DE ZAVALA ROAD TRACT
" Preliminary Master Plan "

PRELIMINARY OVERALL DEVELOPMENT PLAN
OF
OAKMONT SUBDIVISION

RE: Oakmont Subdivision POADP # 340

RE: Oakmont Subdivision
Preliminary Overall Development Plan

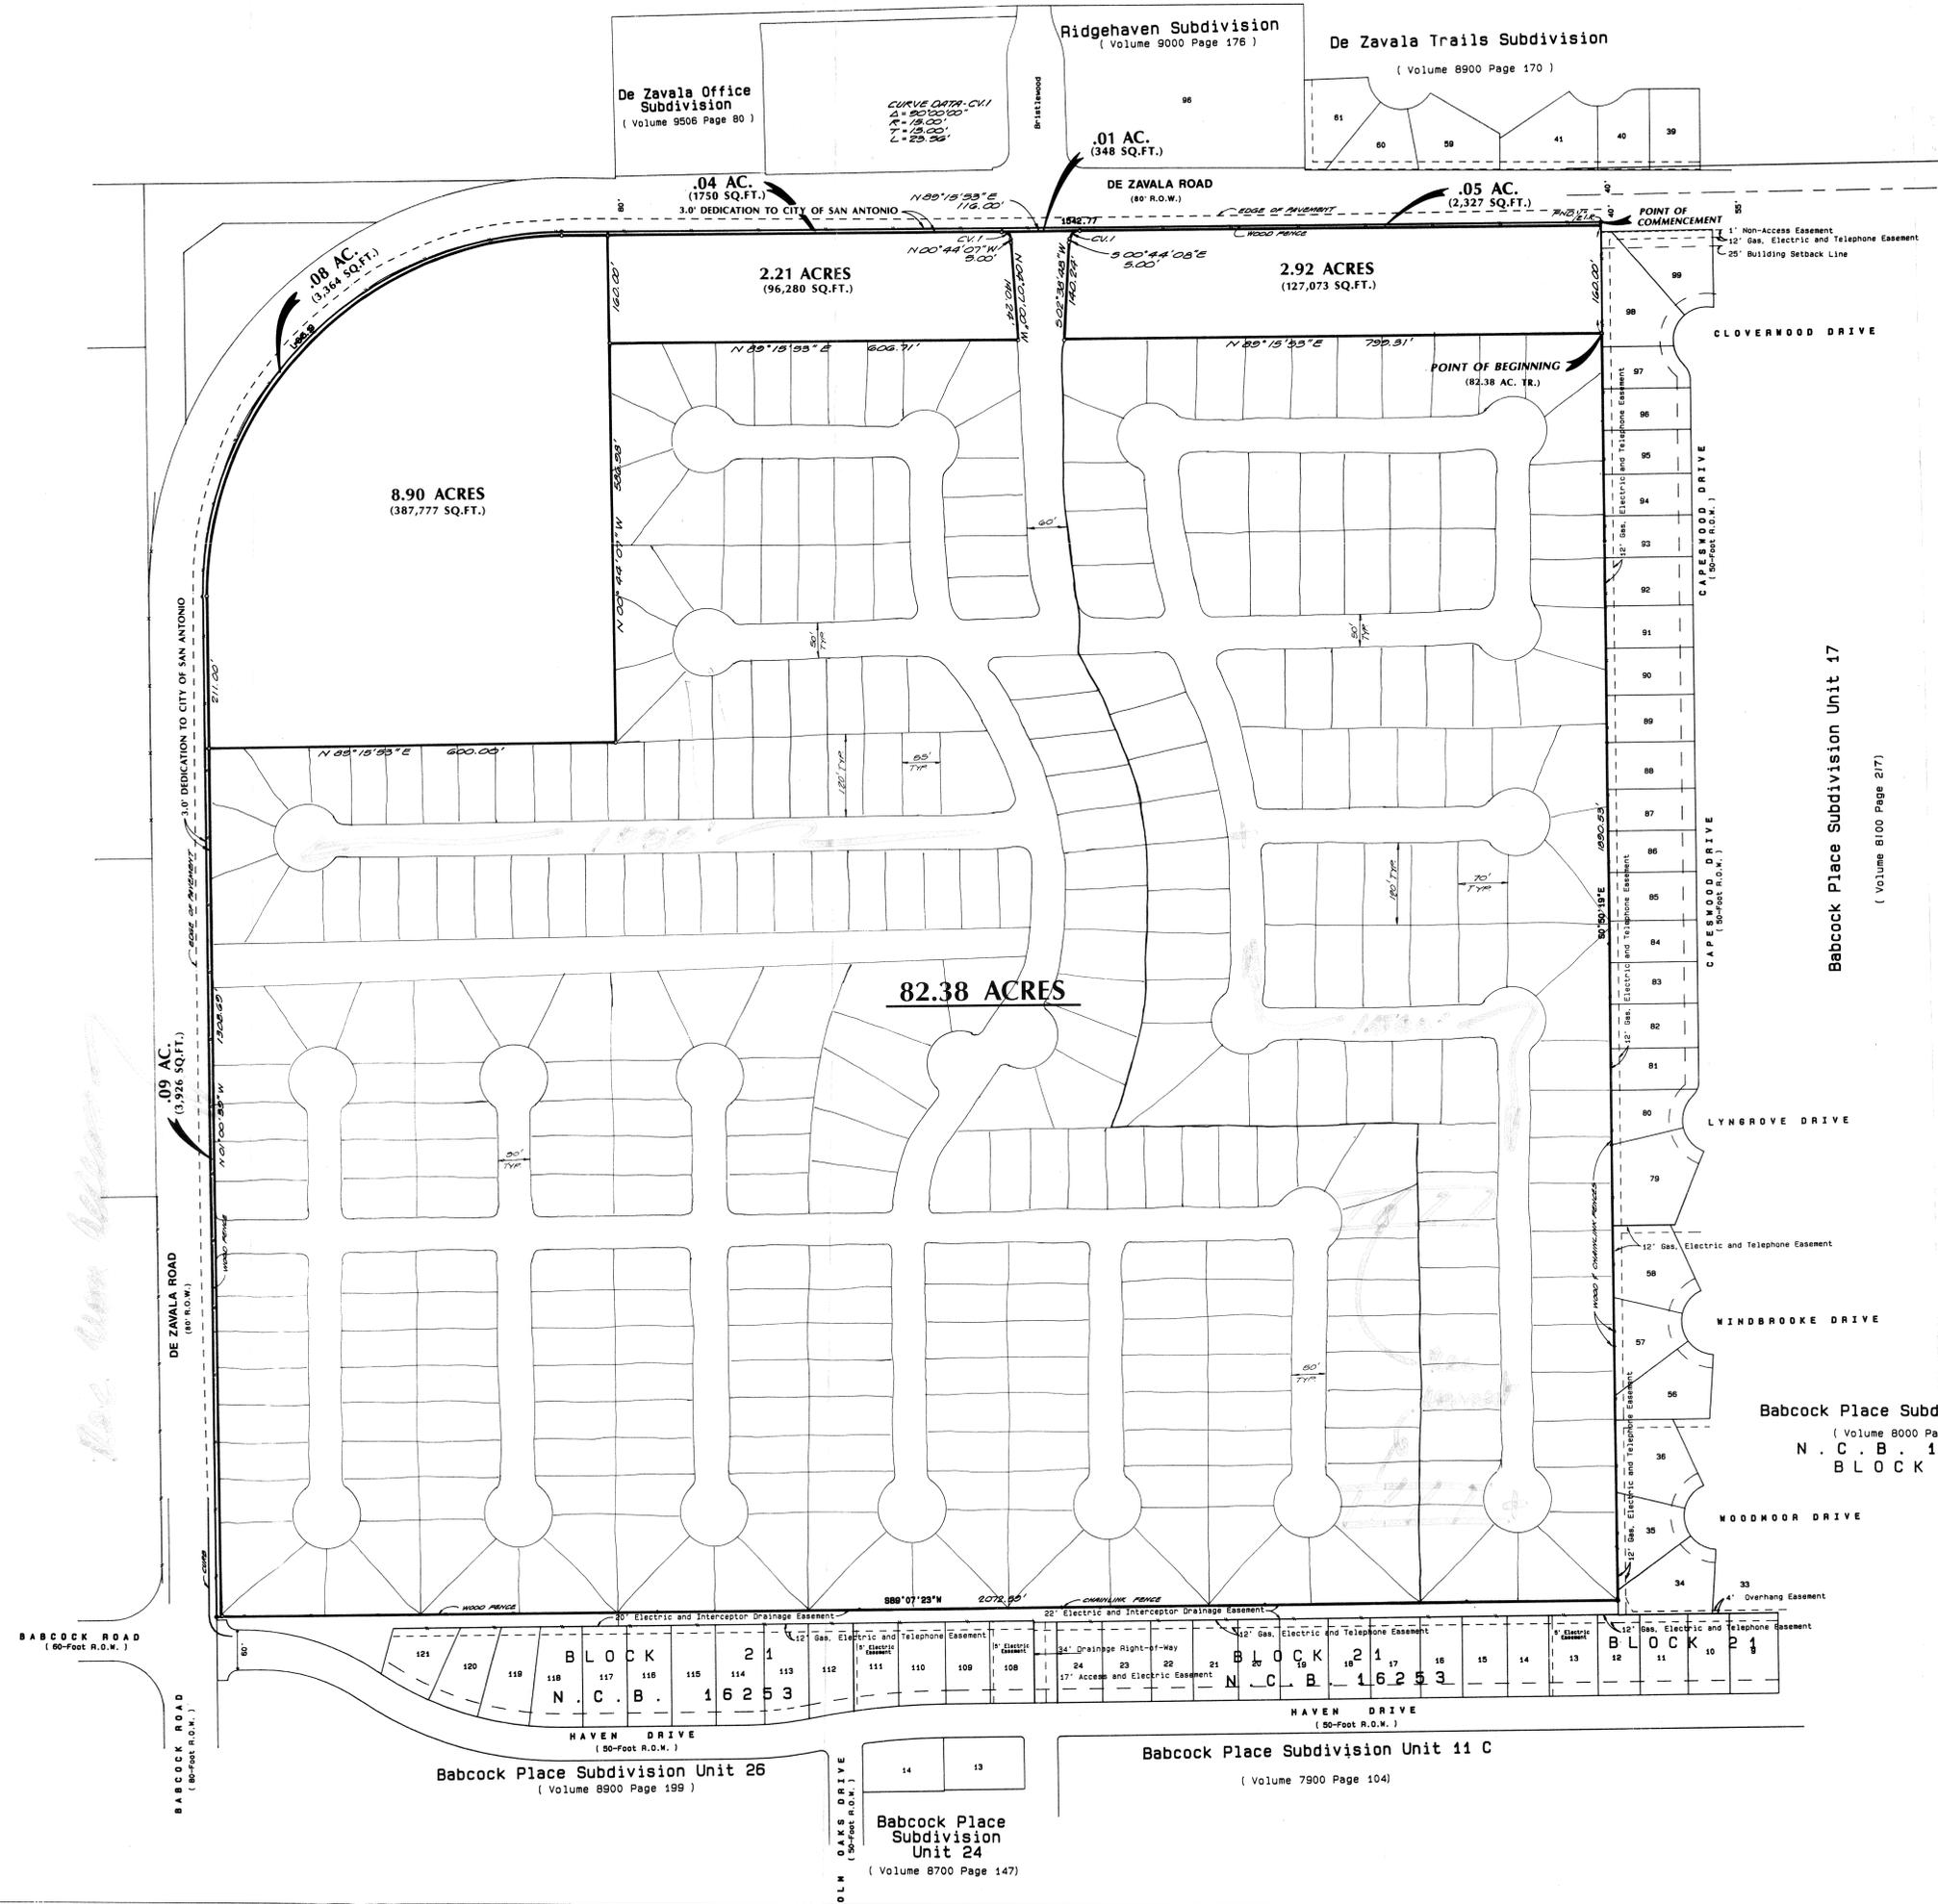
Thank you for seeking pre-comment on the design plan for De Zavala Road tract. The concept was reviewed and it appears to be in general conformance with the Unified Development Code. However, it will be necessary to make provisions for non-access easements for residential lots backing onto De Zavala Road. Also, proposed cul-de-sac streets exceeding 500 feet should be designed in a manner to cause shorter lengths.

We have reviewed your letter of September 29, 1992 providing staff comment to the Preliminary Master Plan for the DeZavala Road tract. We will make provisions for non-access easements for residential lots backing up to DeZavala Road, as you requested, and will incorporate the easements onto the POADP.

Regarding the layout of cul-de-sac streets, we would like to offer justification for maintaining the current layout. There are two streets in the Master Plan that exceed the general guideline of a maximum of 500 feet for the length of cul-de-sac streets. One cul-de-sac street at the southeast corner of the subdivision is approximately 700 feet long. This area of the subdivision will consist of 70' wide lots that will allow larger homes than in the other areas of the subdivision. The intent of our layout is to separate the two areas of different size lots to maintain an atmosphere of architectural consistency and of like value. We believe that the layout of the cul-de-sac street maintain these ideas, while conforming in general to the Unified Development Code.

The second cul-de-sac street in question is found in the northwest quadrant of the subdivision, south of the 8.9 acre tract, running east-west for approximately 1,100 feet. We feel that there are several issues that justify maintaining this as a cul-de-sac street without connection to other streets. This street will serve approximately 42 lots and if an additional street connection is required from the north, another 16 lots and the traffic they generate will be added to the traffic that this street serves. The additional traffic flow will impact the integrity of the safety and security of this cul-de-sac street. Having the cul-de-sac will also foster an atmosphere of community, providing more of a feeling of a neighborhood rather than just a place to live. Again, our perspective is that maintaining this street as a cul-de-sac without a connection from the cul-de-sac to the north, will provide a safer, more secure development that allows for more of a neighborhood feeling, which we feel is the intent of the Unified Development Code.

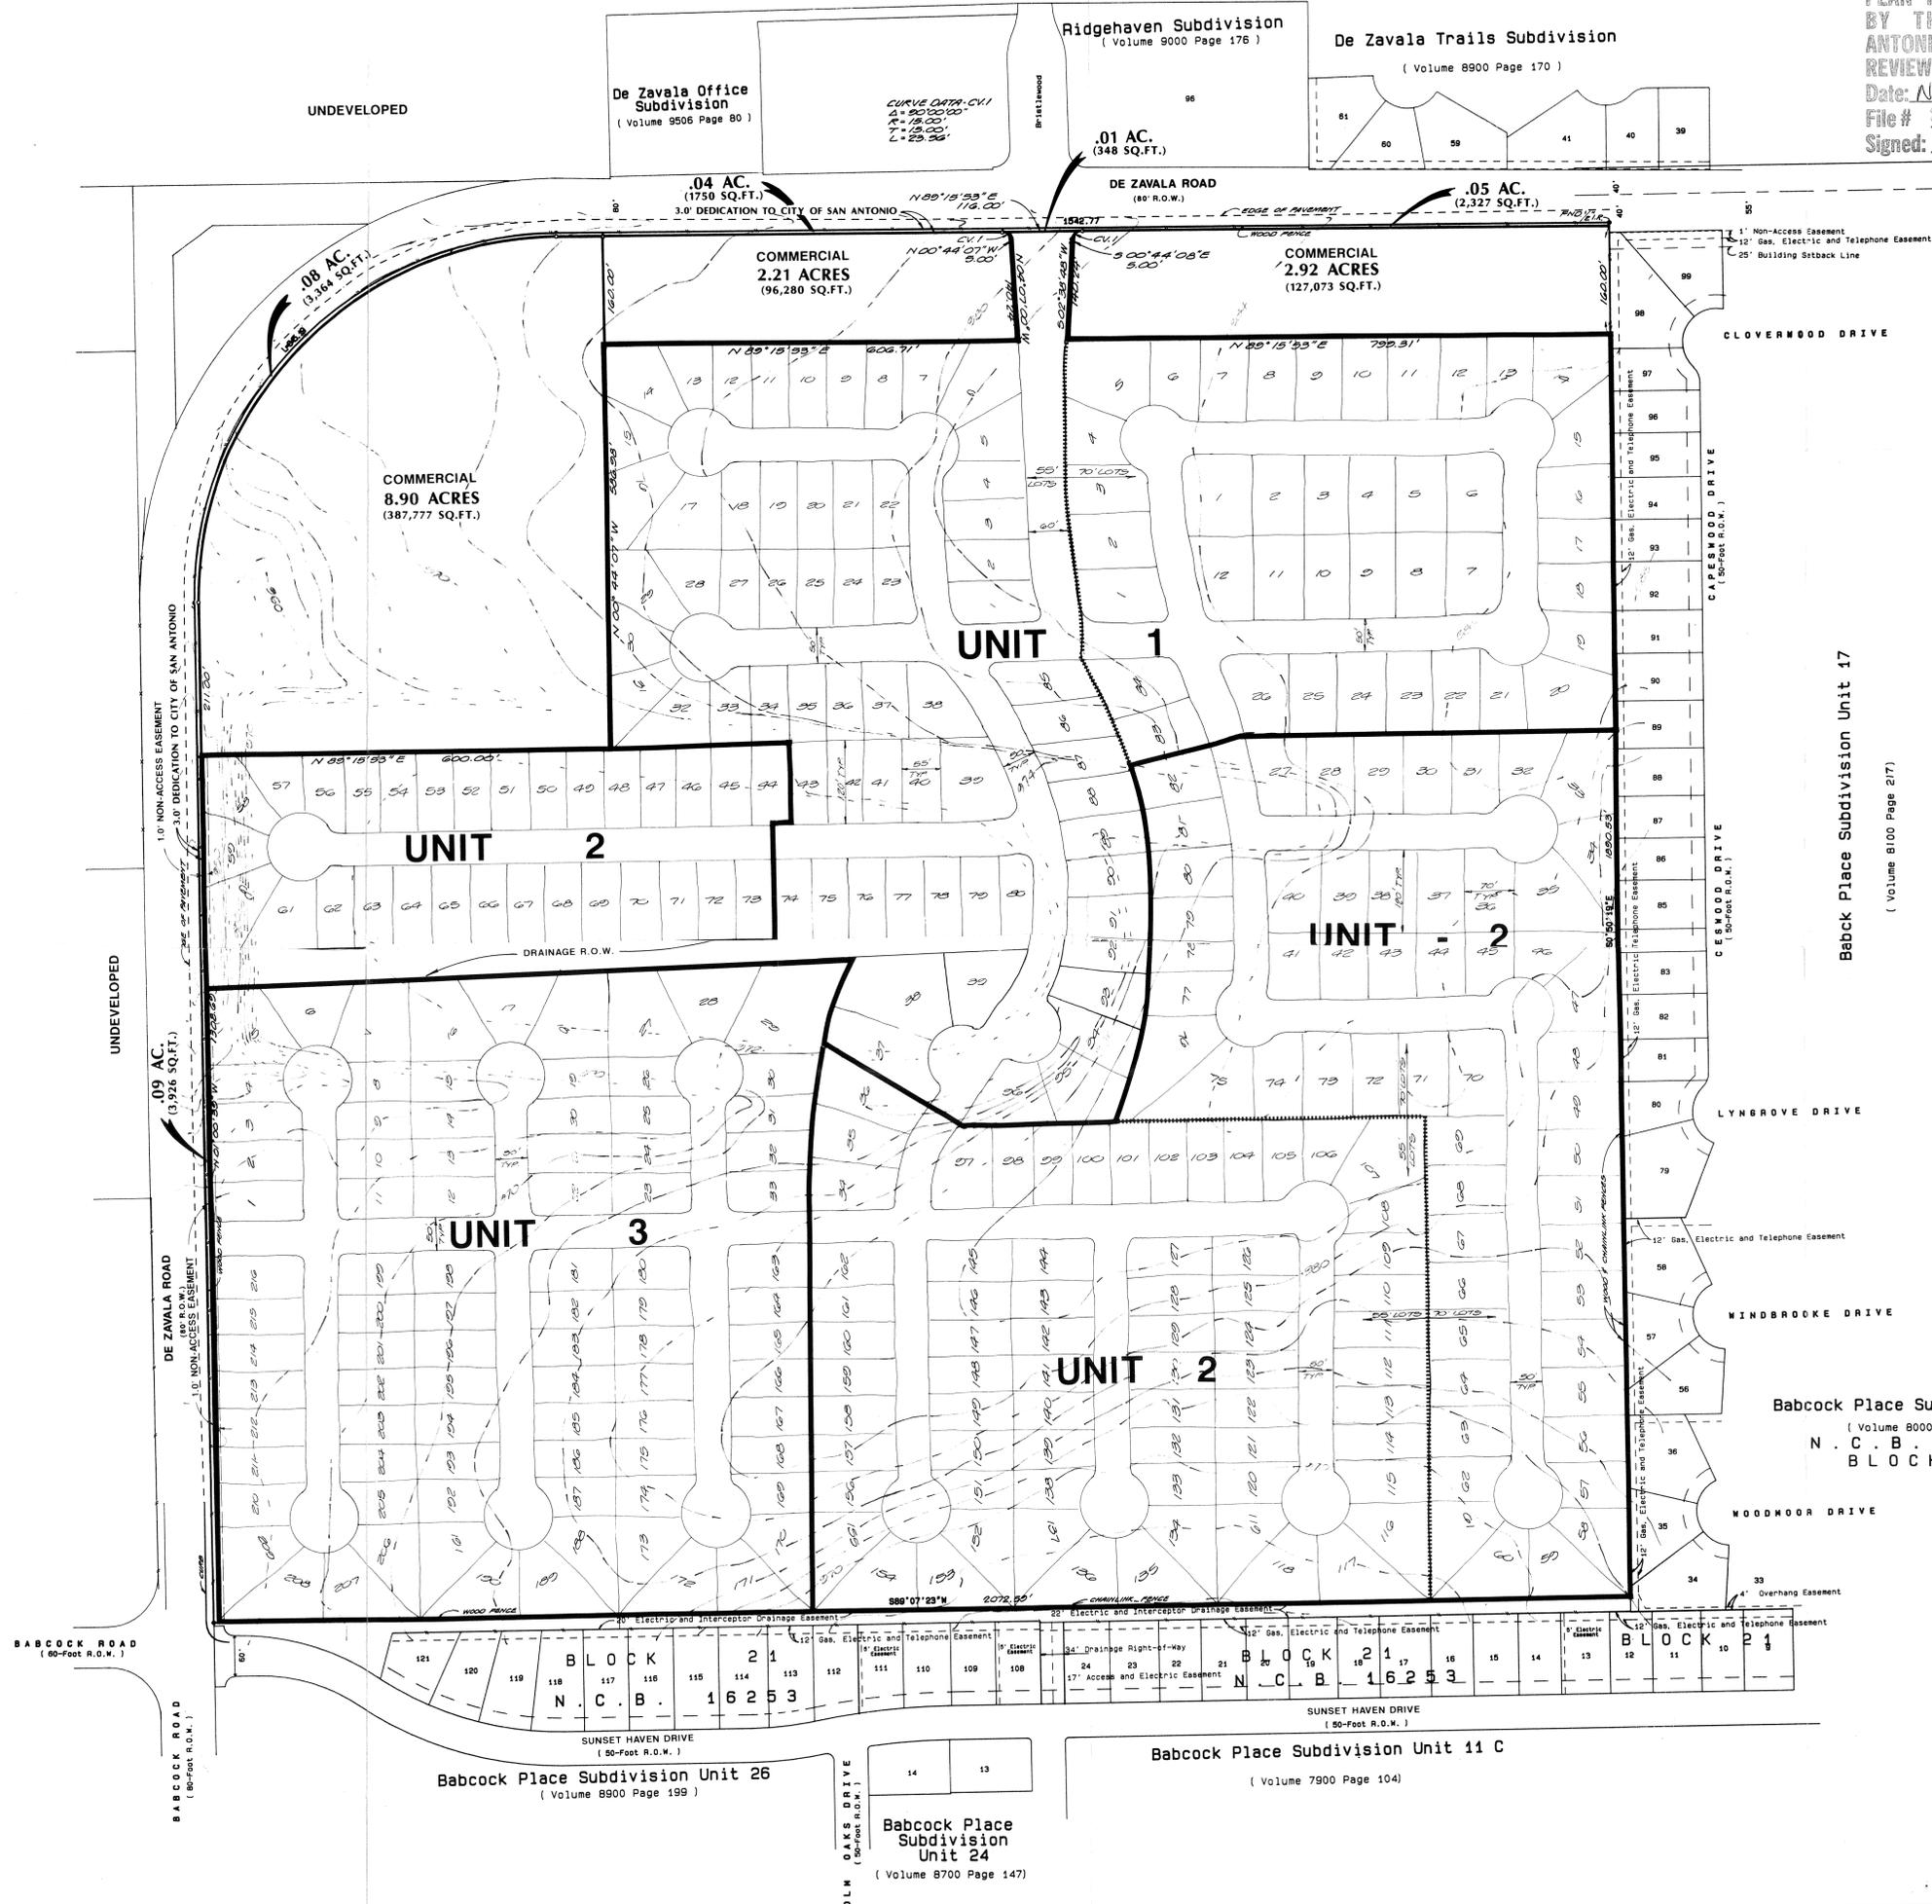
1. The Traffic Design Engineer has indicated a need for a more circuitous street alignment within the overall development.
2. The Fire Department has requested that additional fire hydrants be placed at the end of the longer cul-de-sacs.

Attached please find six (6) copies of the POADP for Oakmont Subdivision for formal Planning Department review and approval. As you are aware, we submitted previous plans for preliminary staff review, and received comments related to a non-access easement for residential lots on DeZavala Road and to the length of certain cul-de-sac streets. We have included the non-access easement for residential lots along DeZavala Road on the POADP.

Regarding the layout of cul-de-sac streets, we would like to offer justification for maintaining the current layout. There are two streets in the Master Plan that exceed the general guideline of a maximum of 500 feet for the length of cul-de-sac streets. One cul-de-sac street at the southeast corner of the subdivision is approximately 700 feet long. This area of the subdivision will consist of 70' wide lots that will allow larger homes than in the other areas of the subdivision. The intent of our layout is twofold. One is separate the two areas of different size lots to maintain an atmosphere of architectural consistency and of similar value. We believe that the layout of the cul-de-sac street maintains this planning idiom, while conforming in general to the Unified Development Code. Secondly, a primary concern of our planning process is to create a neighborhood circulation pattern which discourages thru traffic and minimizes the concentration of volume except on collector streets. Coordinately, the street pattern should encourage safety and allow for security in terms of facilitating the monitoring of unusual traffic (security). The cul-de-sac street at the southeast location serves approximately 21 lots with the current layout. Should there be a requirement to connect this cul-de-sac to adjacent streets, there will be an estimated 50 homes that would have access to this area and would potentially add traffic to this street. This potential for additional traffic creates a safety concern for children in the neighborhood and also impacts the security of the homes as easier access is allowed.

The second cul-de-sac street in question is found in the northwest quadrant of the subdivision, south of the 8.9 acre tract, running east-west for approximately 1,100 feet. We feel that the same issues raised above justify maintaining this as a cul-de-sac street without connection to other streets. This street will serve approximately 42 lots, and if an additional street connection is required from the north, another 16 lots and the traffic they generate will be added to the traffic that this street serves. The additional traffic flow will impact the integrity of the safety and security of this cul-de-sac street.

As we previously discussed, the additional traffic generated by the connection would create a less safe environment for children of the neighborhood as they play in and around the neighborhood. The easier access also creates an easier avenue for theft to occur. Therefore, it is our position that it is in the best interest of the neighborhood safety and security to leave the layout in its current configuration.
